**PECOS DISTRICT  
CONDITIONS OF APPROVAL**

30-025-40046

OPERATOR'S NAME:	Devon Energy Prod Co
LEASE NO.:	LC061863A
WELL NAME & NO.:	6H Trionyx 6 Federal
SURFACE HOLE FOOTAGE:	200' FSL & 2260' FEL
BOTTOM HOLE FOOTAGE:	330' FNL & 1650' FEL
LOCATION:	Section 6, T. 25 S., R. 32 E., NMPM
COUNTY:	Lea County, New Mexico

Figure 1 – Cross Sections and Plans For Typical Road Sections

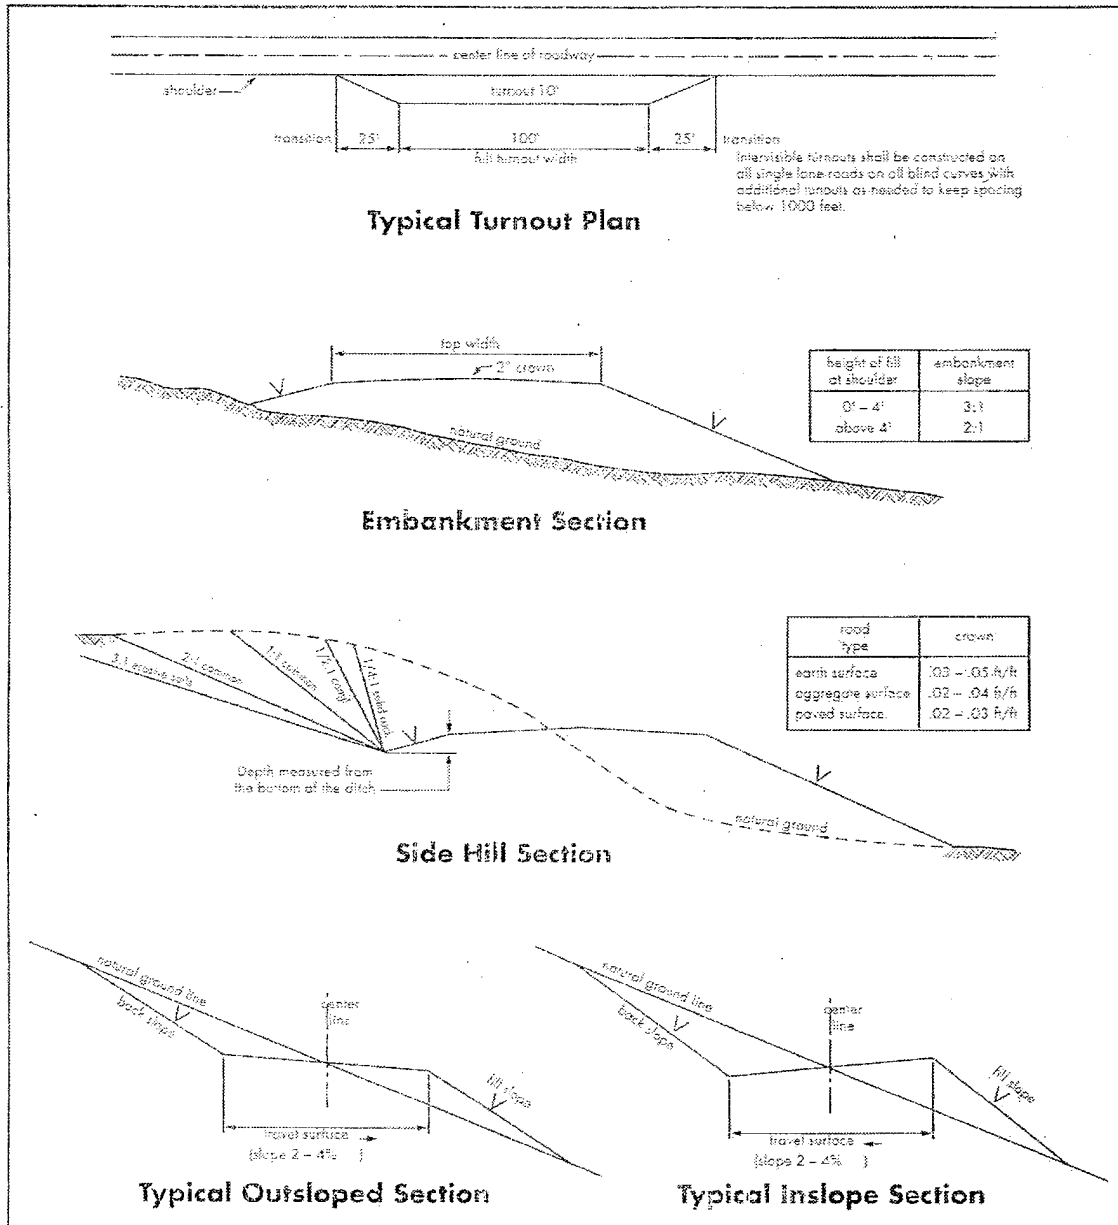
Crowning shall be done on the access road driving surface. The road crown shall have a grade of approximately 2% (i.e., a 1" crown on a 14' wide road). The road shall conform to Figure 1; cross section and plans for typical road construction.
